# Easton Staff Development Review MEETING AGENDA

**Project Name:** Somerset Well Drilling

**FROM:** Joseph A. Mayer - Plan Reviewer, Planning & Zoning Department  
**SUBJECT:** 28580 Mary's Court, Lots 16 & 20

We reviewed the **January 2, 2025** Sketch Plan Submittal for the Subject Project and have the following comments:

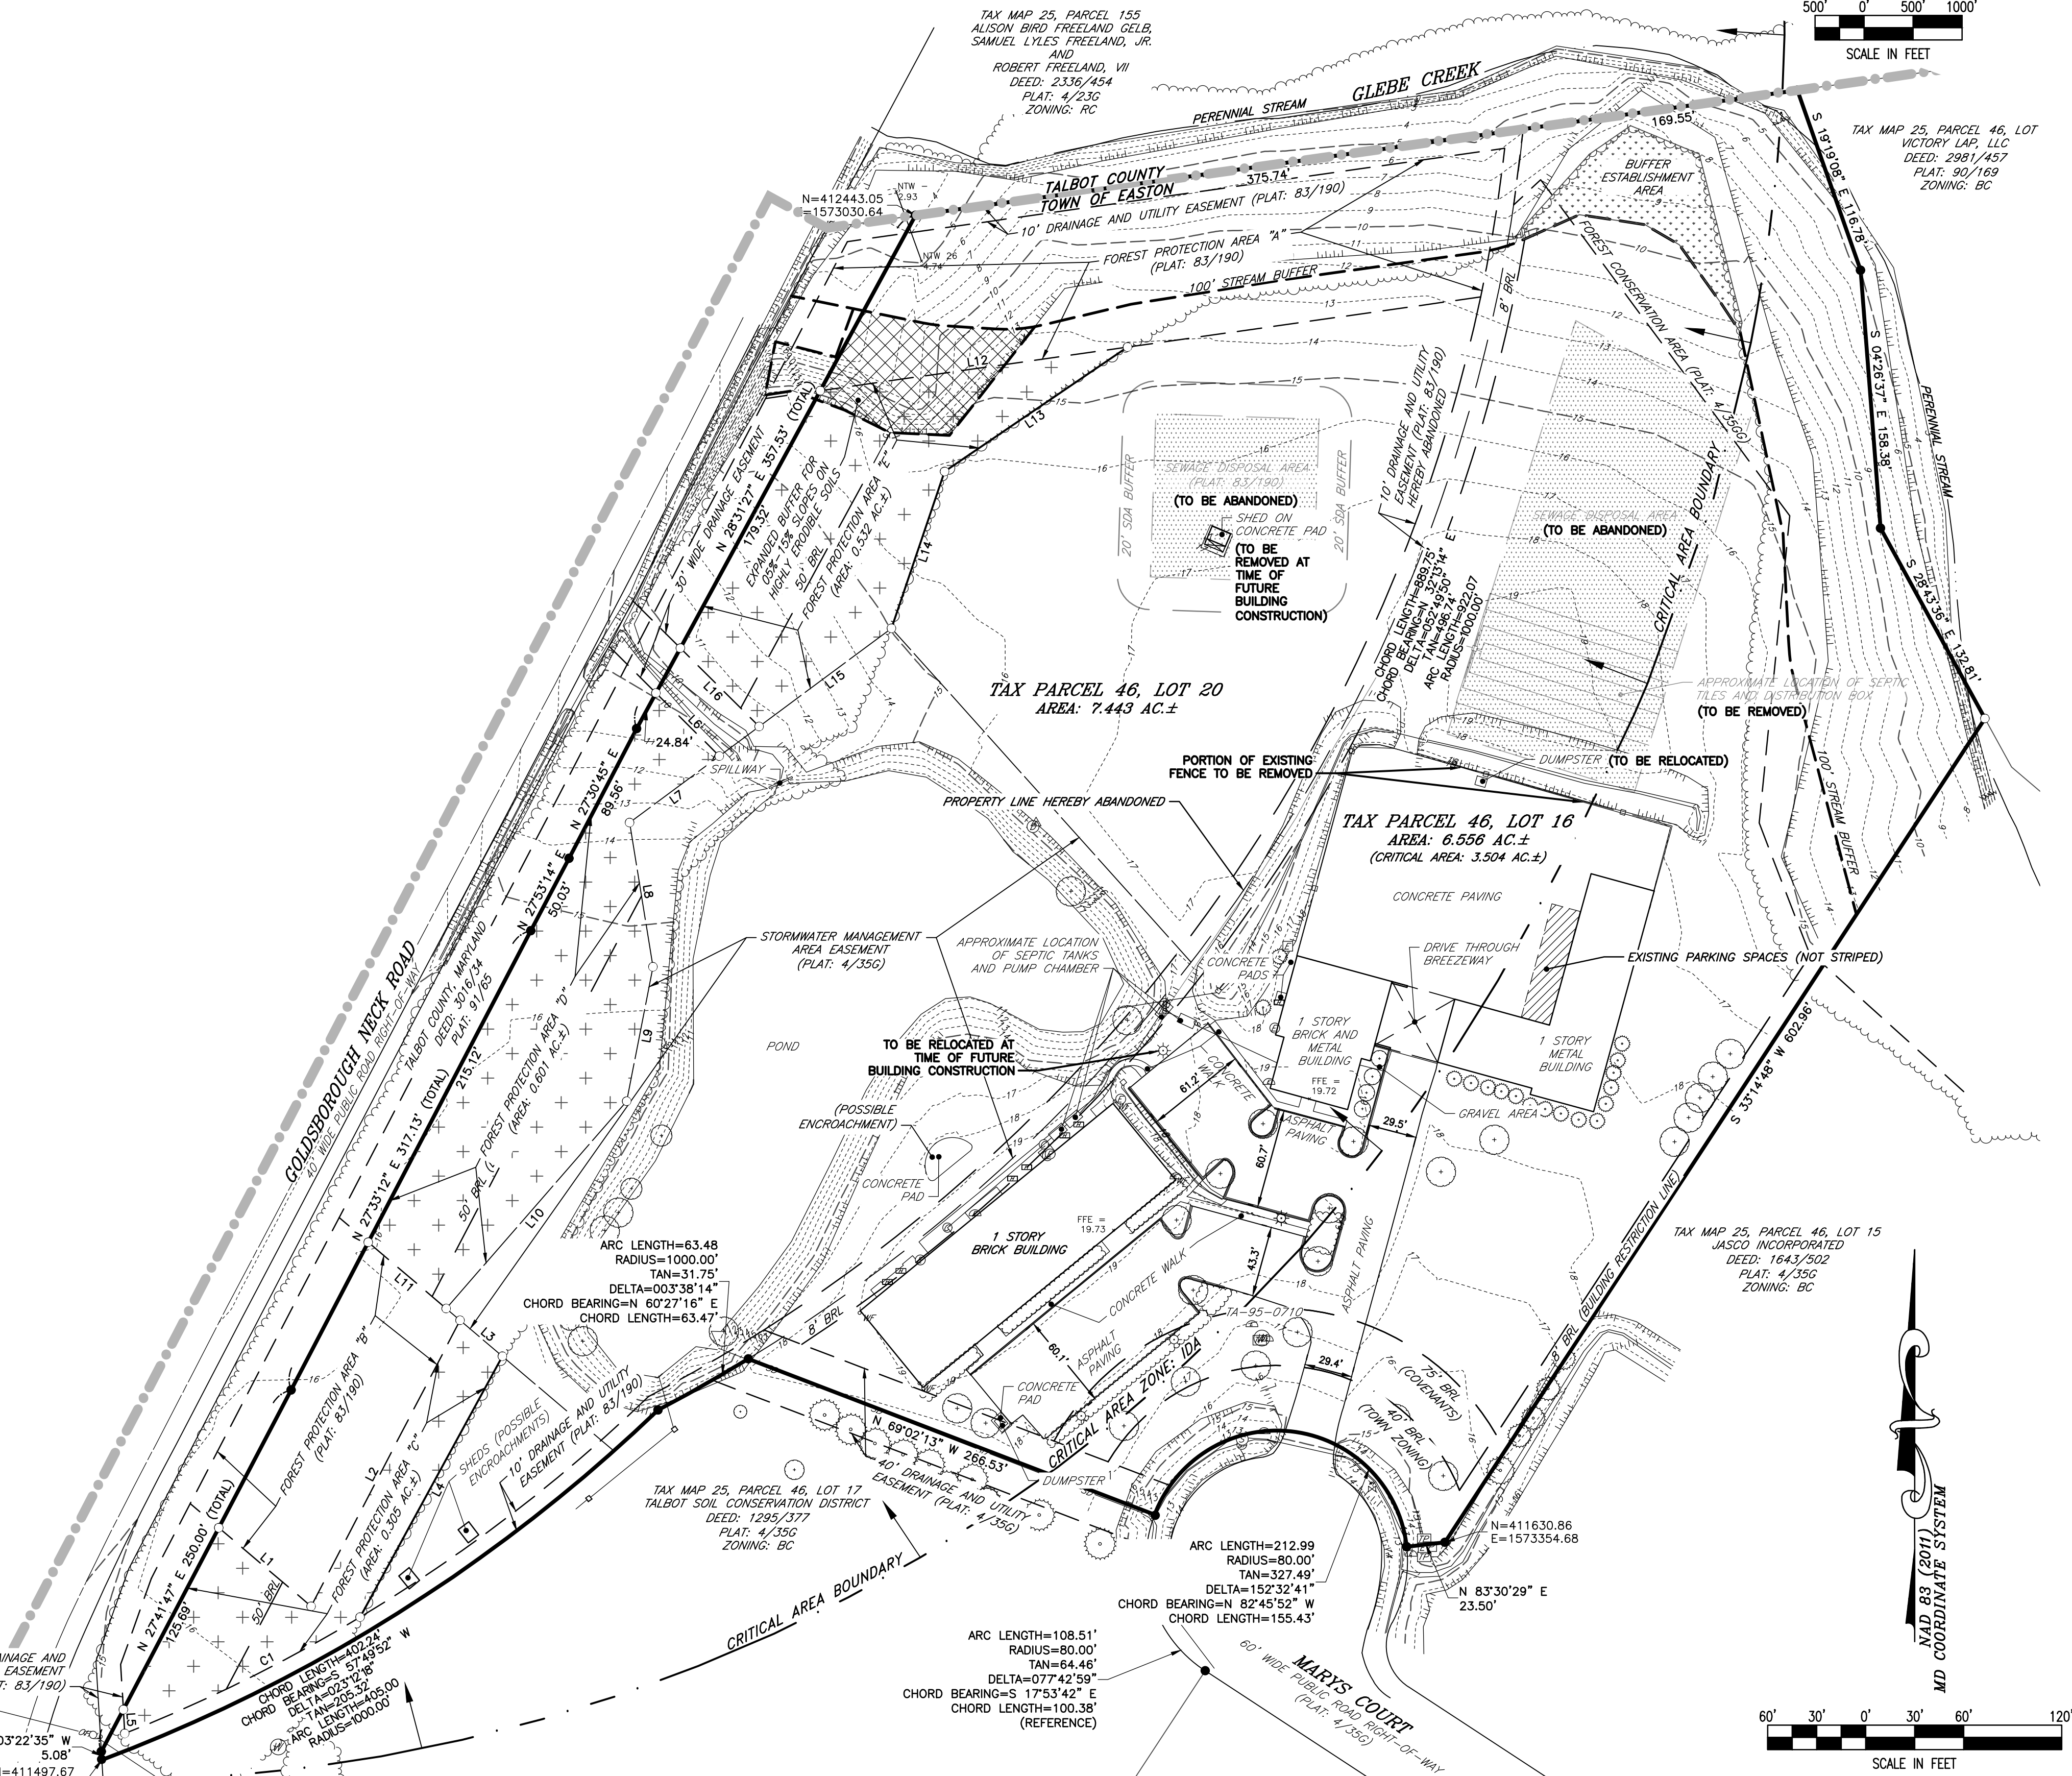
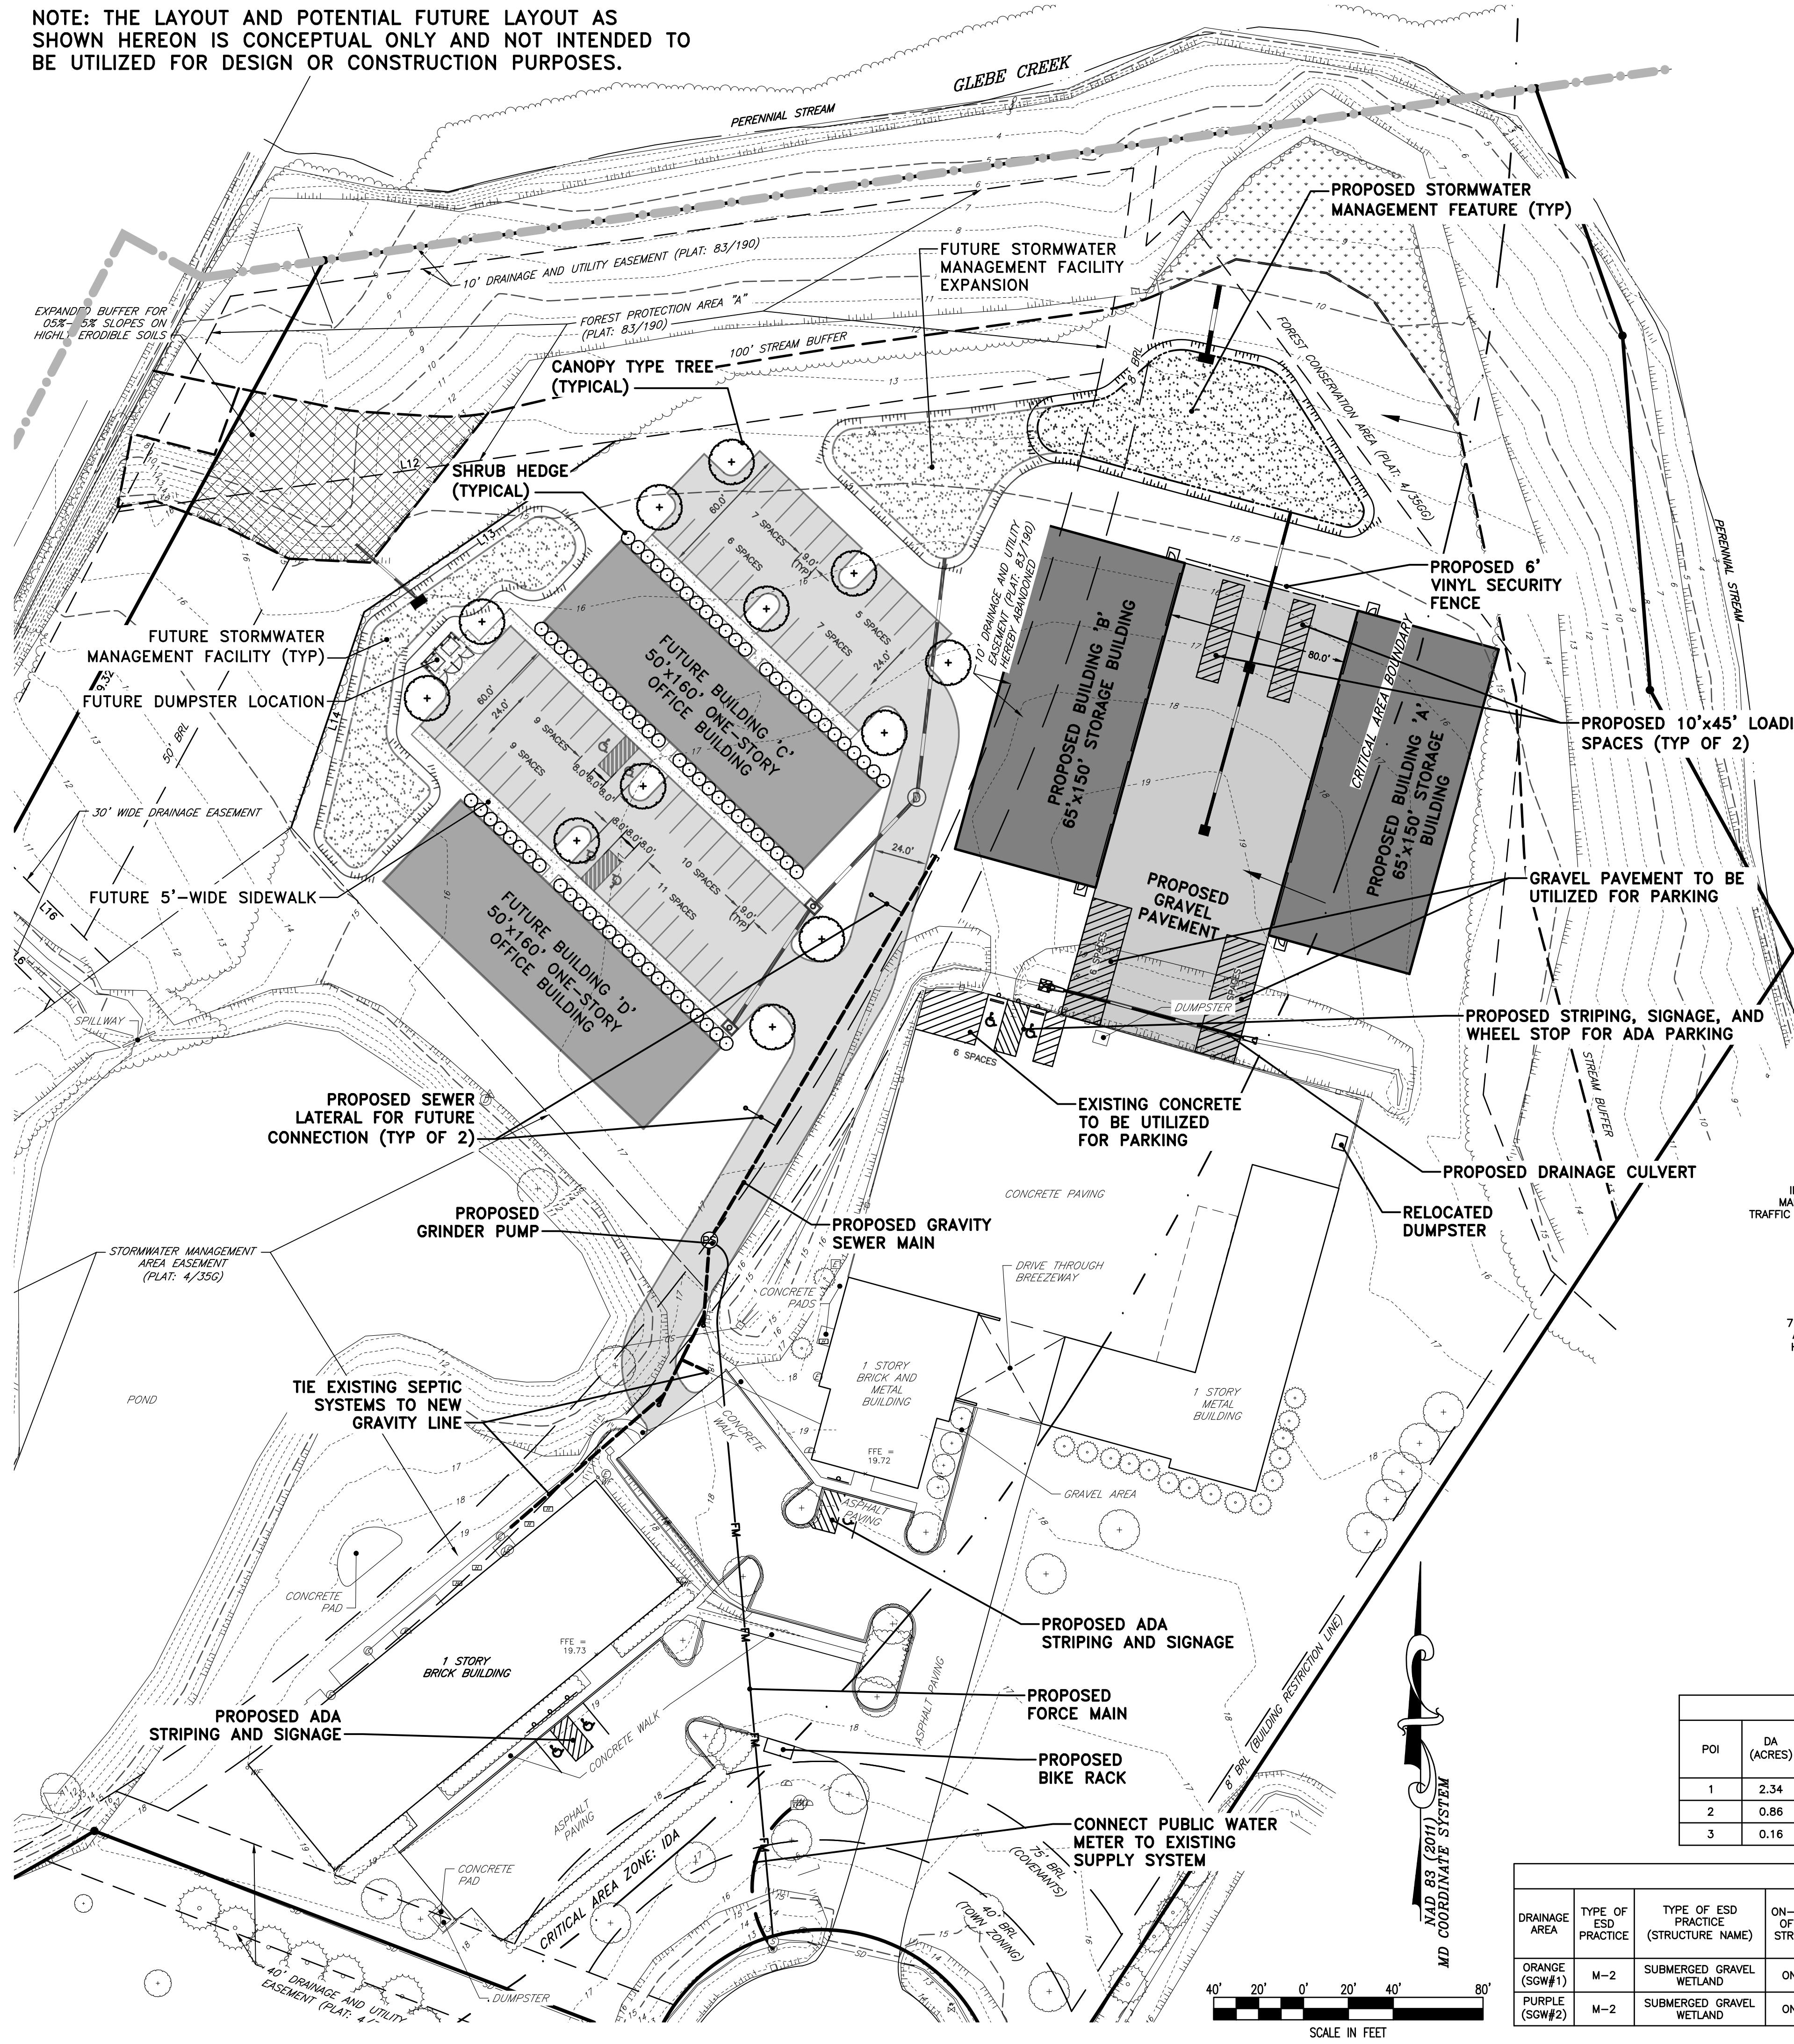
9. Label all existing road paving widths on all plan views.
10. Dimension the width of the proposed gravel pavement.
11. Revise *Development Data \*Note* on Existing Conditions Plan, sheet 1 of 2, to reference the Critical Area Commission's condition of obtaining approval within the 120 days of the Commission's approval dated November 6, 2024.

12. Revise *Development Data Phasing Note* on Existing Conditions Plan, sheet 1 of 2, elaborate more in detail if the drive aisles and parking facilities for future buildings 'C' and 'D' will be constructed during Phase 2.

13. The *Project Notes* and *Comprehensive Plan Design Principles Response Narrative* have overlapping text on the Existing Conditions Plan, sheet 1 of 2. Revise text for legibility.

16. Revise the *Parking Required* within the Development Data on the Existing Conditions Plan, sheet 1 of 2, to include the existing parking requirements

*The \*Note has been updated to specify that the approval letter dictates that the map designation change must be reflected on the Town's critical area map within 120 days from the date of the letter.*

*The note has been revised to explain that Buildings C and D and their associated parking lots and stormwater facilities are to be constructed in a future second phase.*

1 FRONT ELEVATION  
1/8" = 1'-0"

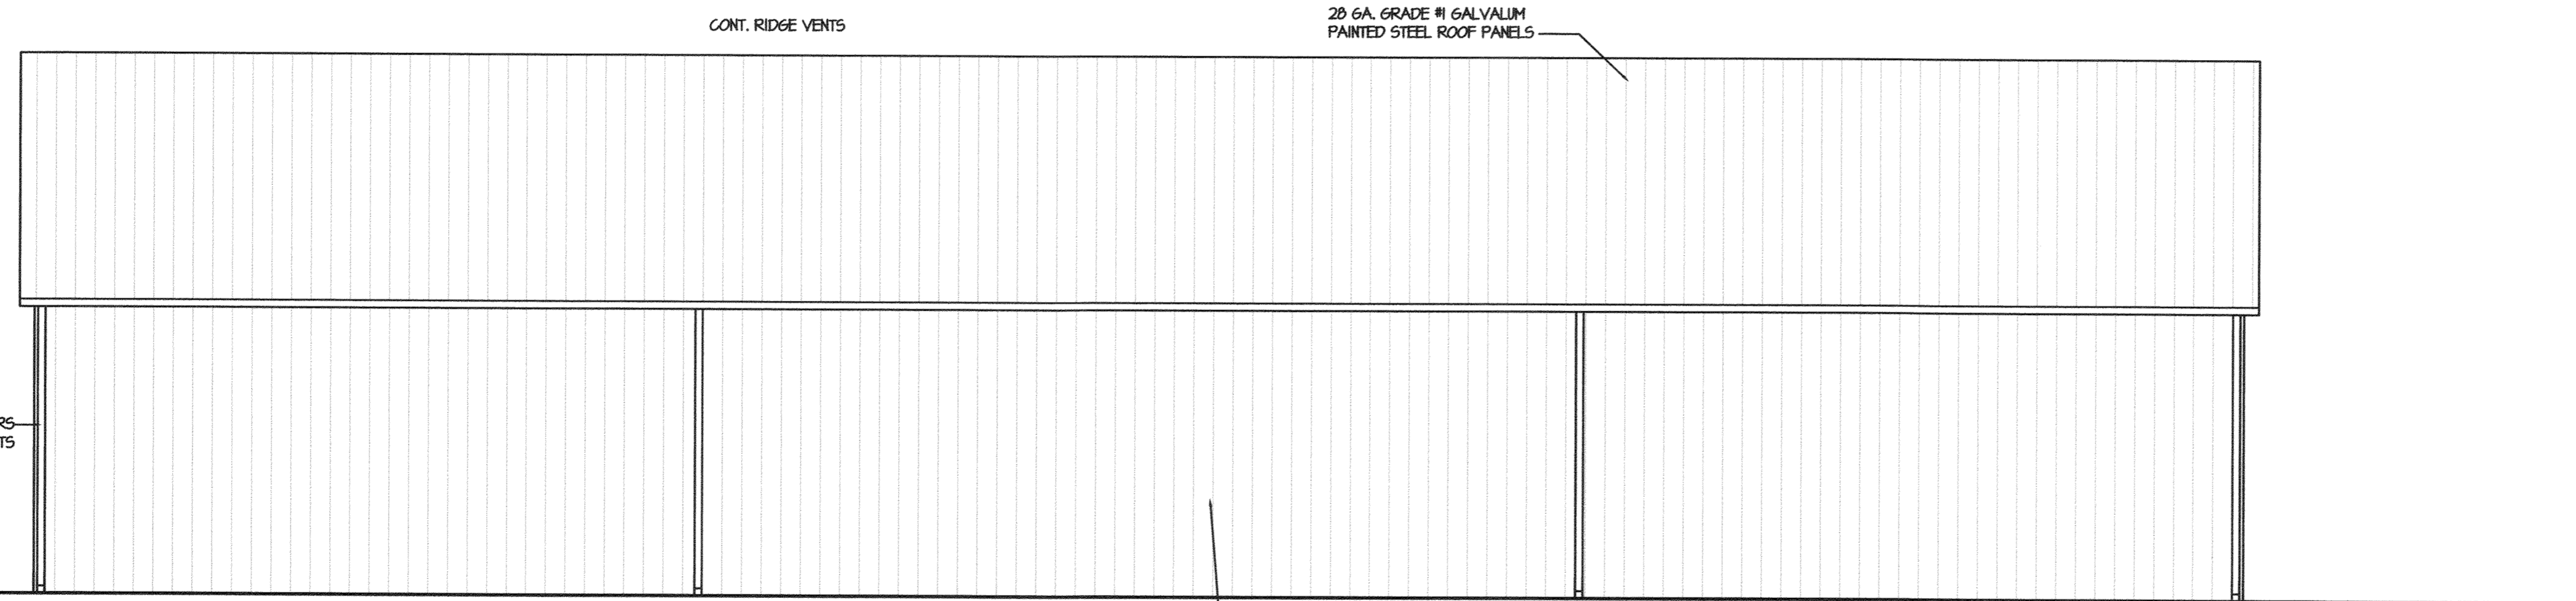
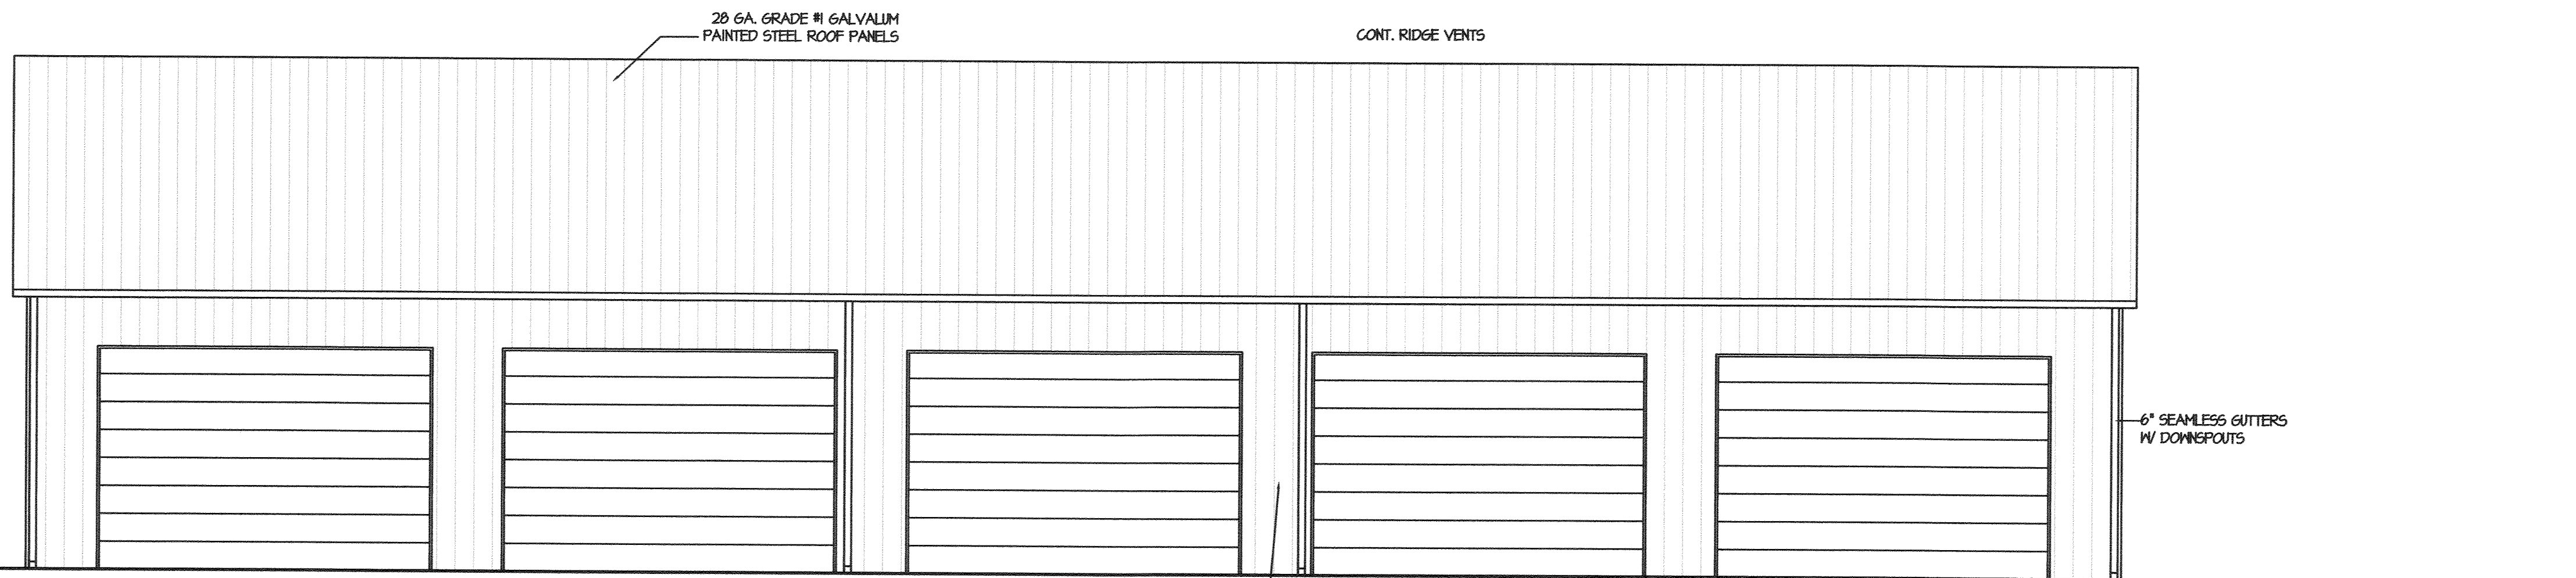
1. Per Appendix B, Sketch Plan Submittal Checklist requires *conceptual building elevations or renderings illustrating the character, scale, and materials of all proposed structures. Such elevations or renderings shall be sealed by a licensed professional as described above.* Provide a color elevation for the exterior of the proposed buildings.

2. The ESDR Application indicates two three-sided pole buildings. The architectural plans depict a four-sided building with garage doors. Please revise.

*Apologies. The building labels, project notes, and applications have all been updated to remove references to a 3-sided pole building.*
